Access Compliance Report

Public Rights-of-Way

(Pedestrian Signals)

Intersection ID: N/A	Main Street:	Cross Street: N/A	Location: N/A
ADA ID: 952151BE6FEB	Signal Type: One Push Button-APS	Overall Compliance: No	Severity Score: BTN 1: N/A BTN 2: N/A No BTN: N/A
Codes/Mitigation Info/Possible Solution		Field Measurements/Component Compliance

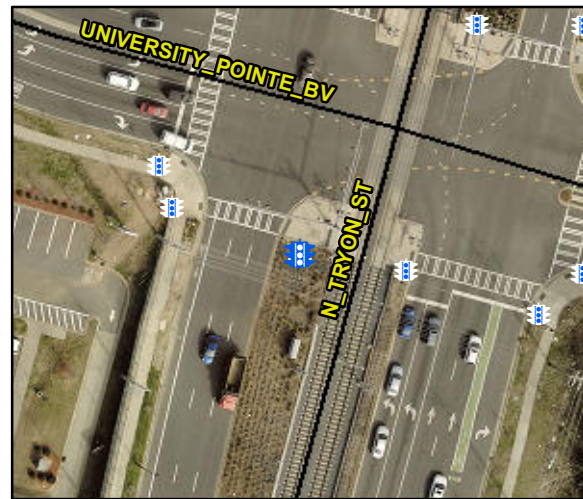
PROW/ADA: R404.7.3, R404.7.2, R209.1,
MUTCD 4e.10,

Possible Solutions: Remove & Replace
Replace APS Button With New APS Button.
Remove and Replace Clear Space.
